April 14, 1994
LD-94-024

Docket No. 52-002

Subject: System 80+™ Information for Issue Closure

The attachments to this letter provide revisions to CESSAR-DC and comments on the System 80+ FSER. Attachment 1 provides additional structural design detail and revisions to CESSAR-DC discussed with Mr. T. Cheng and Mr. S. Ali. Attachment 2 provides our comments on the FSER, per the referenced letter. Attachment 3 provides a clean copy of technical revisions to the Technical Specifications which were agreed upon at the April 5-6, 1994, meeting with NRC staff. These should be given to Mr. M. Reinhart. These revisions and the agreed-upon format changes will be formally printed in Amendment W (May 31, 1994).

DEISEL FUEL STORAGE STRUCTURE
REINFORCING DETAILS

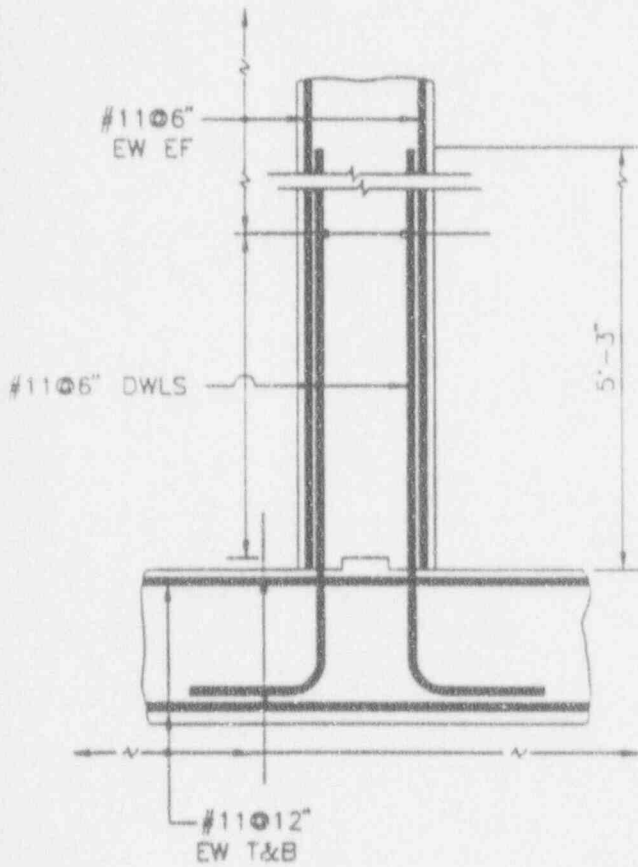
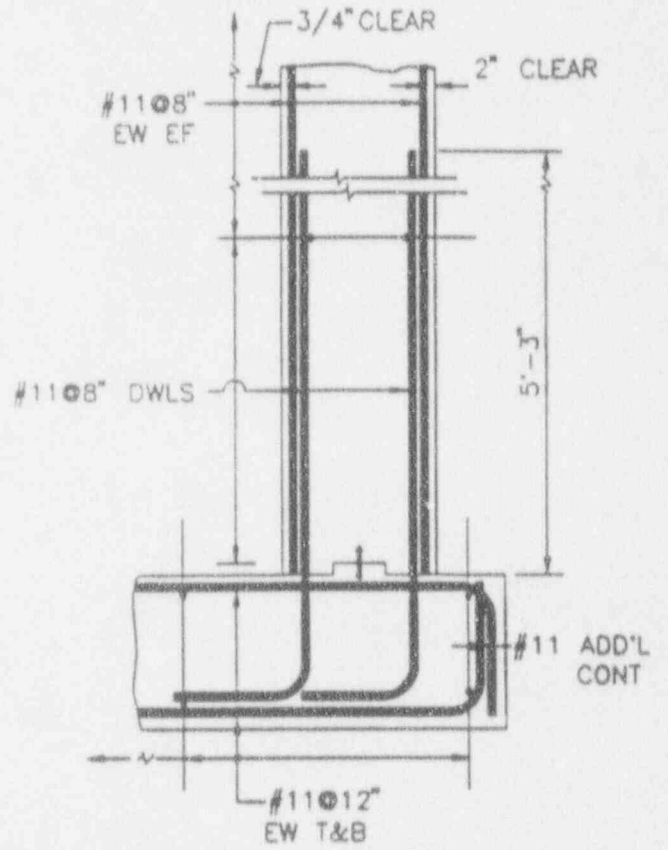
The main reinforced concrete structure is approximately 25 ft high, 63 ft long and 44 ft wide founded on a ~~two-foot~~ ^{2'-3"} thick reinforced concrete mat located ~~4'-6"~~ ^{12'-6"} below the grade elevation of 90'-9". The walls and the roof are ~~two-foot~~ thick. There is a two foot thick center reinforced concrete wall that divides the structure into two separate bays. Each bay encloses a diesel fuel oil tank, a tank vent, a sump with a sump pump, and necessary piping. The bays are separated from each other and from the equipment room by ~~one~~ ^{three} hour rated fire barriers (i.e., 2 ft thick walls). A steel platform at elevation ~~91'-0"~~ ^{89'-3"} surrounds each of the fuel tanks. The outside doors are protected against tornado missiles by a concrete missile barrier. ^{15"}

FIGURE 3.8B-9
~~SHEET 3 OF 3~~

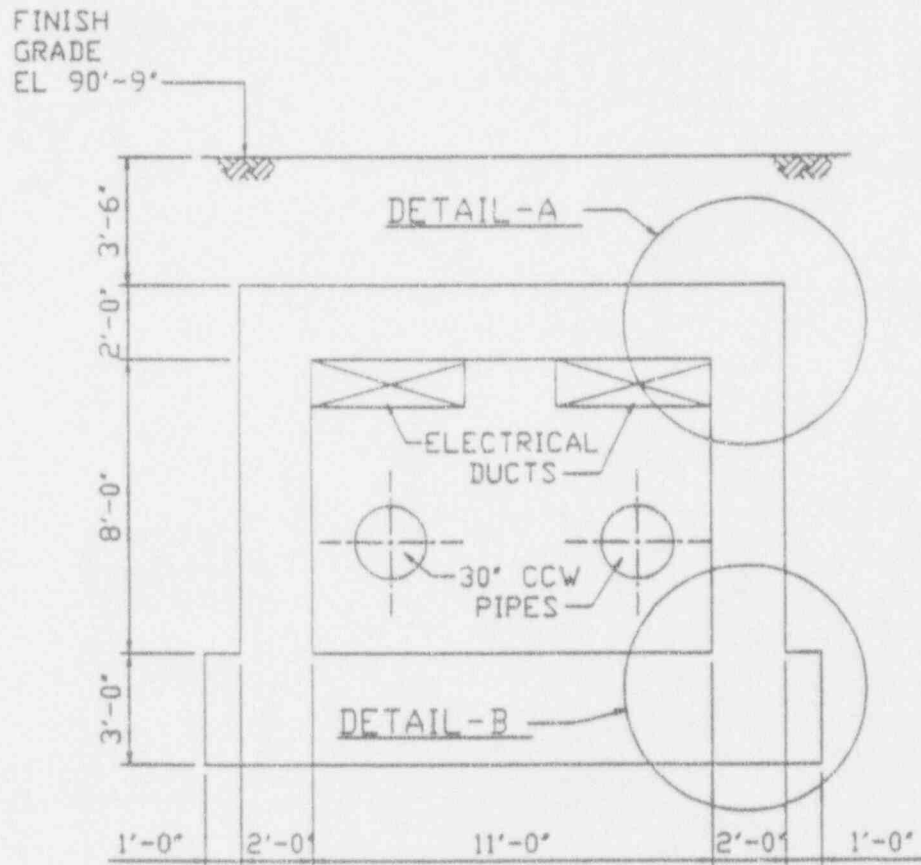
~~No transverse shear reinforcing is required.~~

FIGURE 3.8B- //
~~SHEET 2 OF 2~~

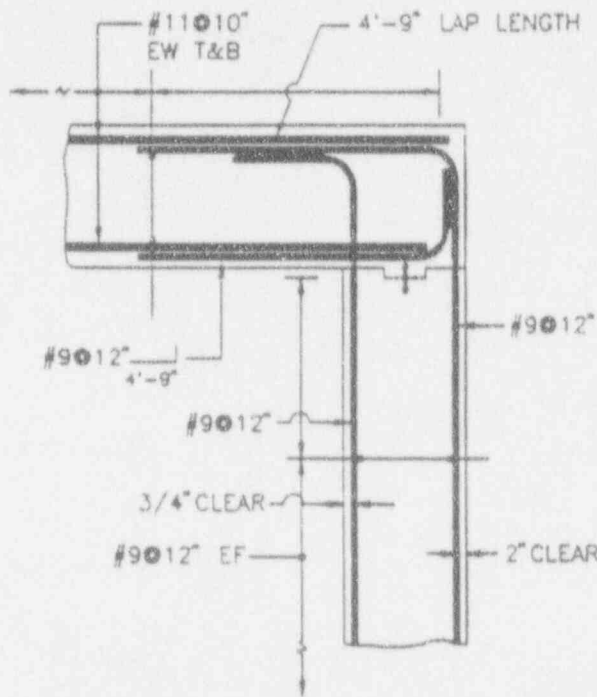
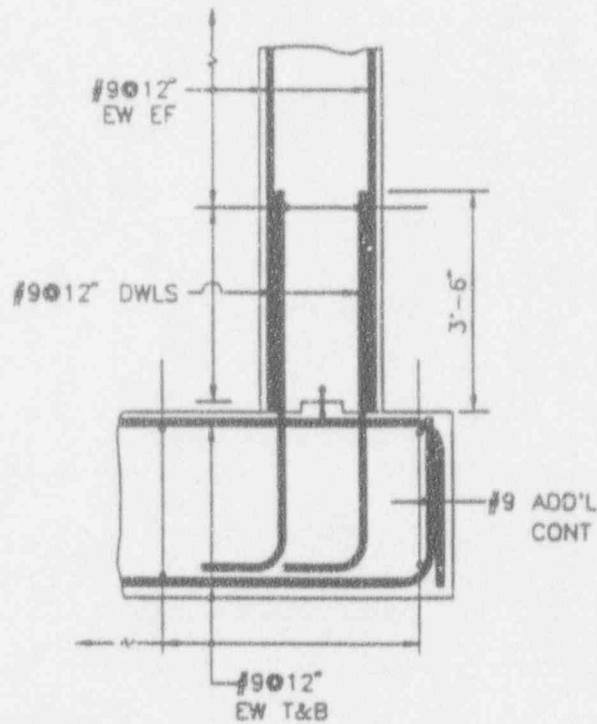
~~SHEET 1 OF 2~~
